**STATUS STAMP**

**CONTRACT**  
Stephenson House - Commercial

**TITLE**  
OFFICE  
Residential Block  
Roof Level  
Combined Services  
Co-ordinated Services Layout

SCALE: As indicated @ A0 DRAWN: CADTECH DATE: 01/12/20  
DRG No.: 8555-MALA-PR-RF-DR-X-7104

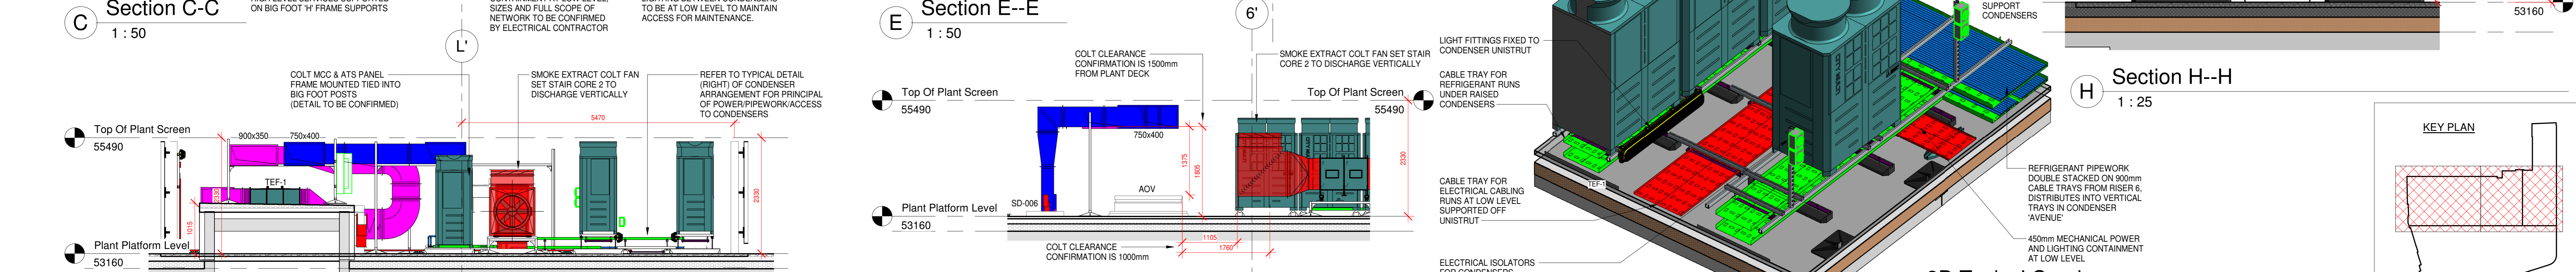
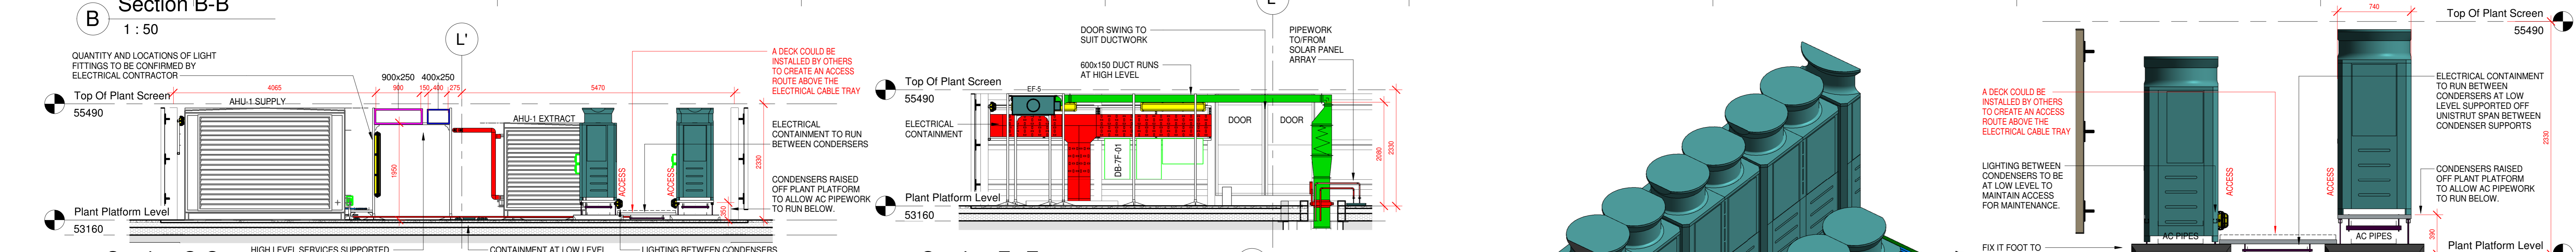
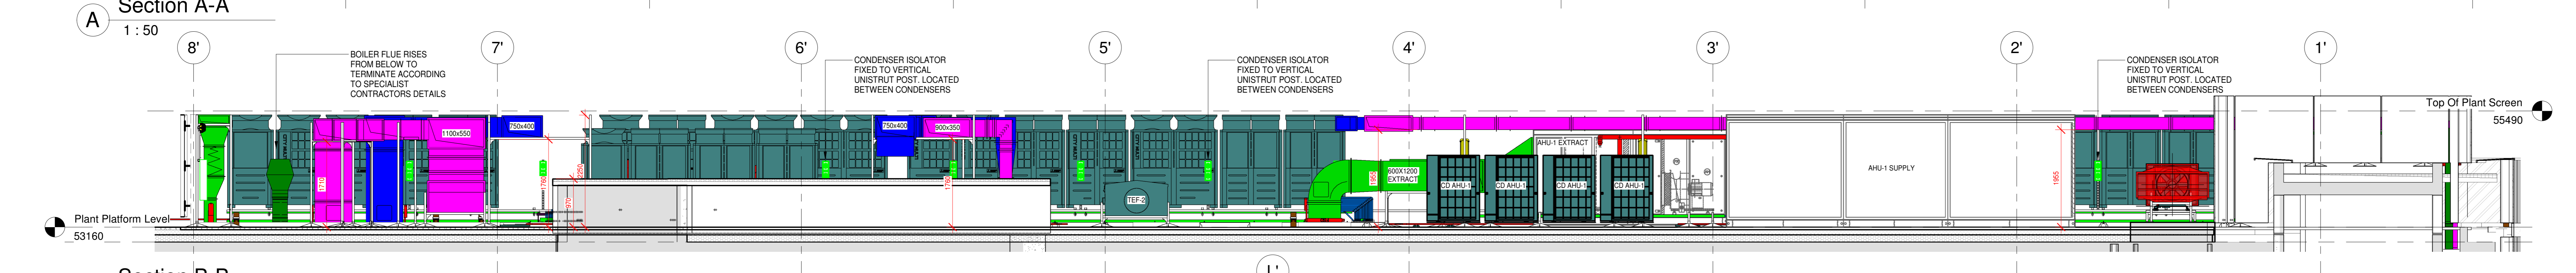
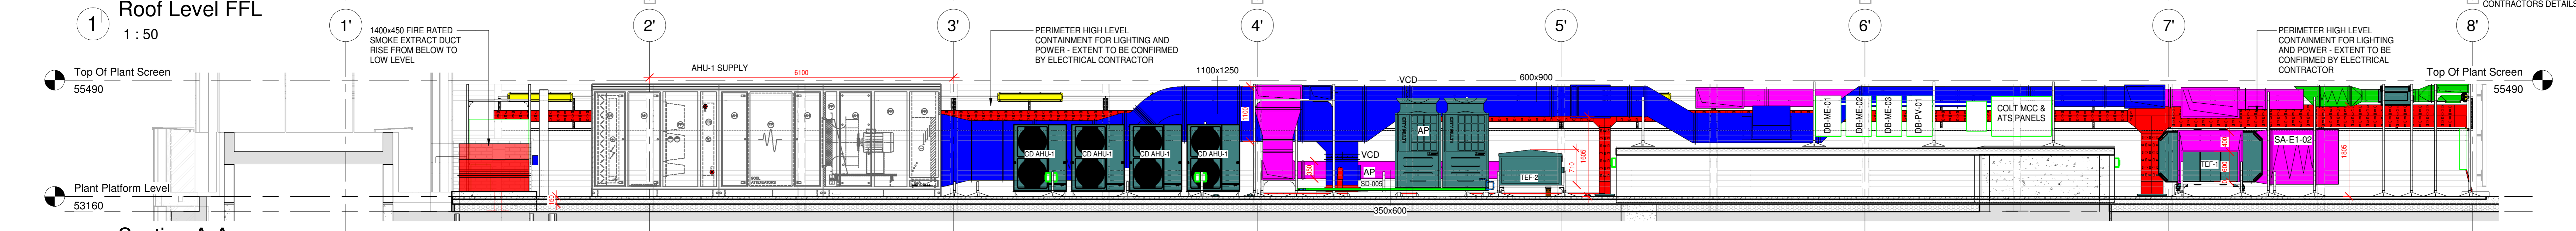
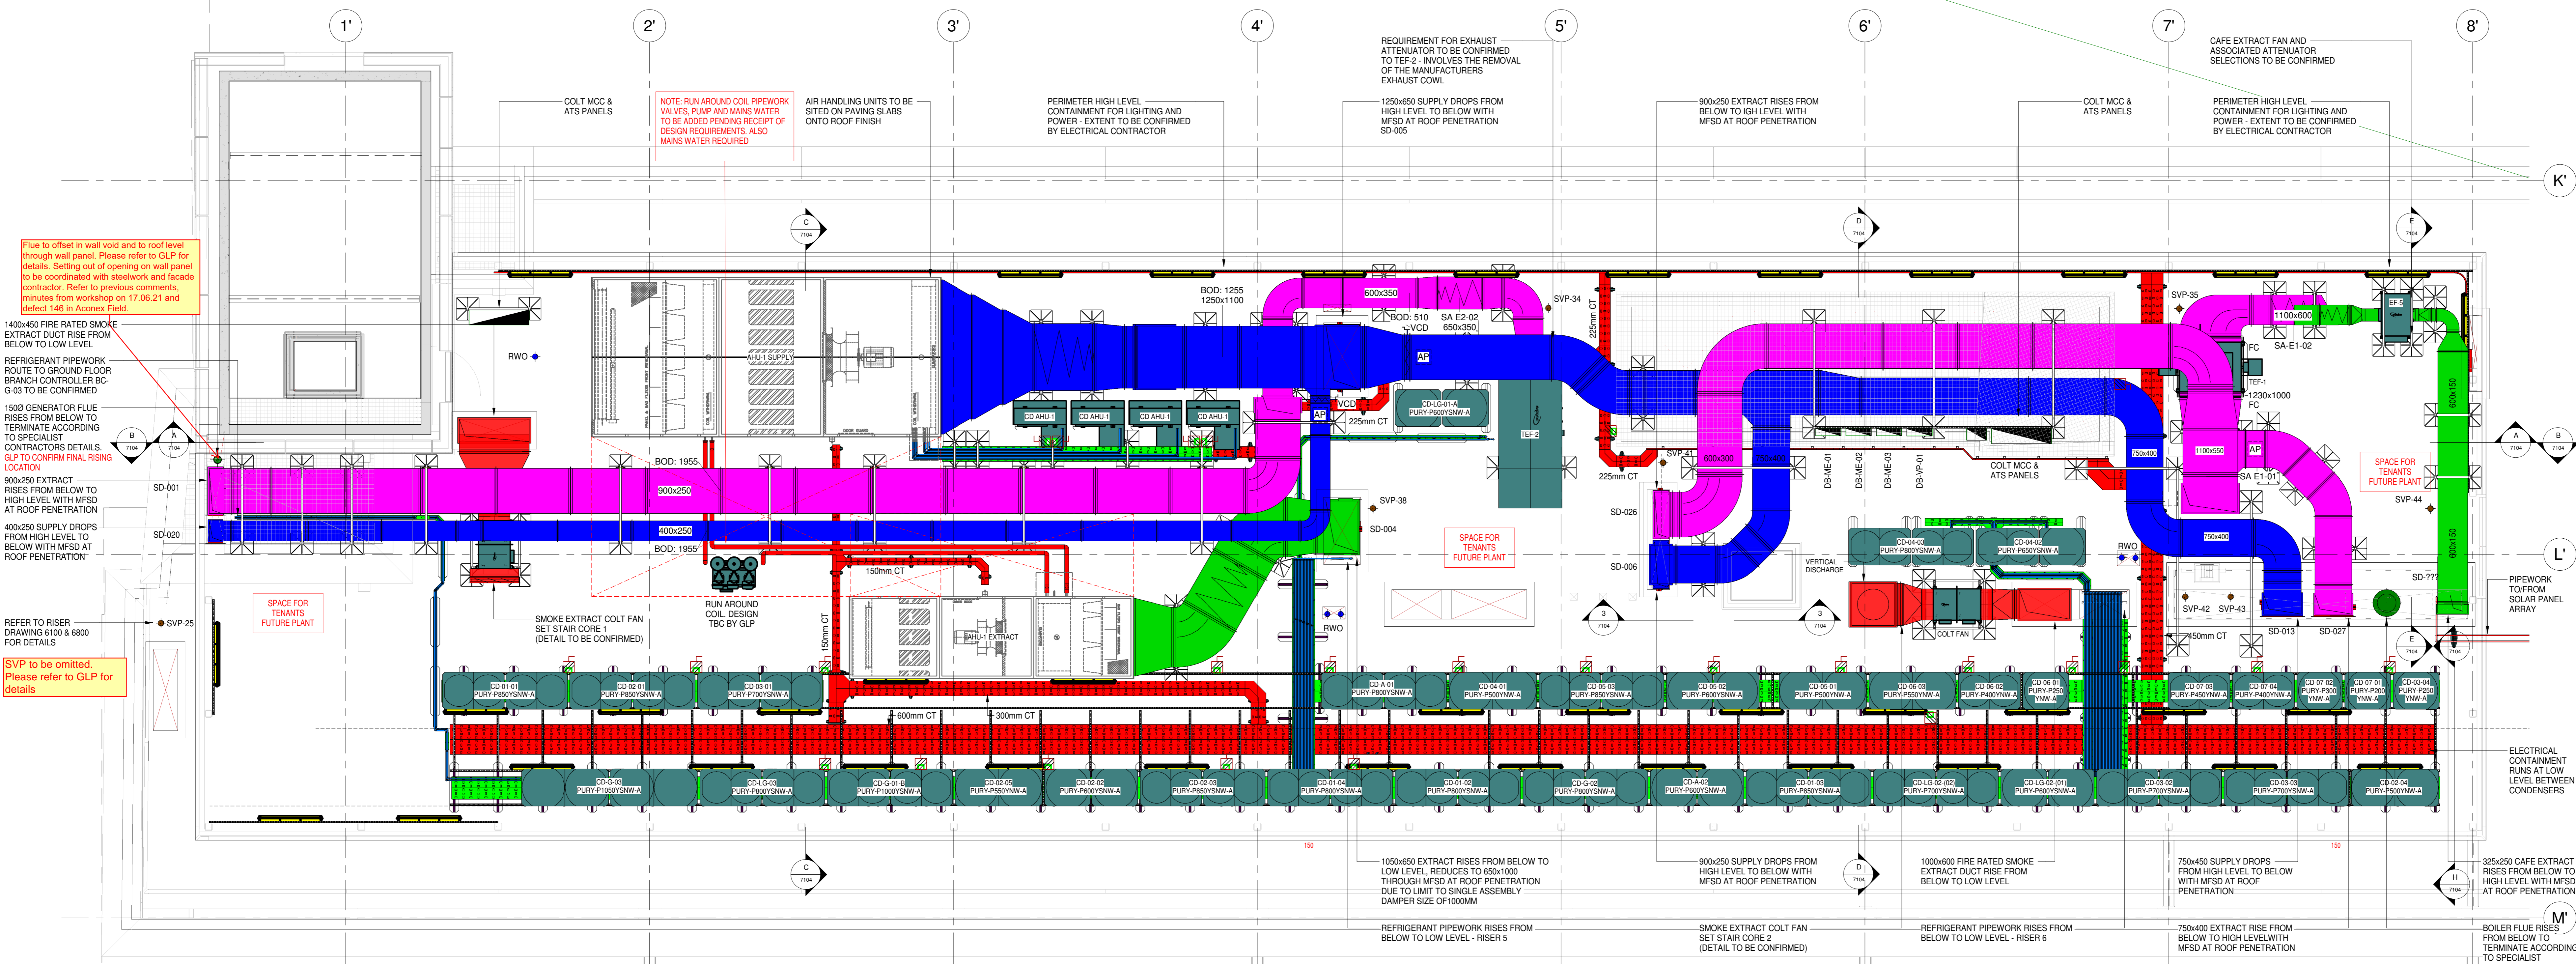
Setting out dimensions in floorplan have disappeared. Please add

As previously commented, the level of services needs to be coordinated with Dura Composite Access platform. Access platform level (53.160) doesn't seem to consider the minimum platform height, as per Dura-composites' technical submittal. Platform needs to sit on the attenuation cells; with the levels shown in this drawing, it would leave only 45mm for the access platform. Refer to drawing A-1410 for roof levels and build-up. Please clearly indicate the correct level of the access platform. All services to be under plant screen level.
